Re: First Technical Review: Green Valley Ranch East – Tibet Road (38th Ave to Trib T) Preliminary Plat

Application Number: DA-1662-12

Case Number: 2020-6041-00

First Technical Review

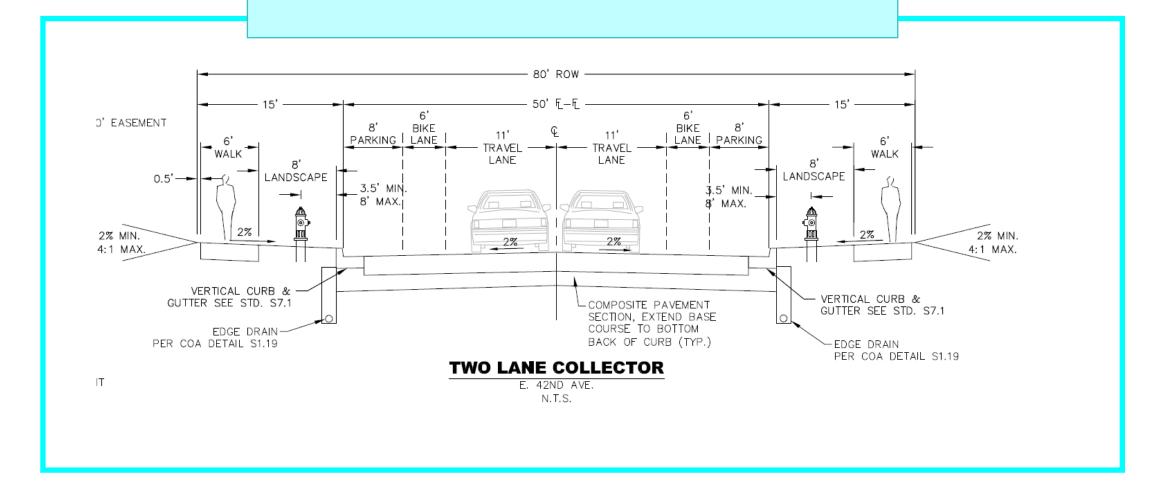
Add a detail for 42nd Ave. The one below is what is included in Flg #3

DEWBERRY RESPONSE: TYPICAL SECTION OF COA TWO-LANE COLLECTOR HAS BEEN ADDED TO THIS SHEET.
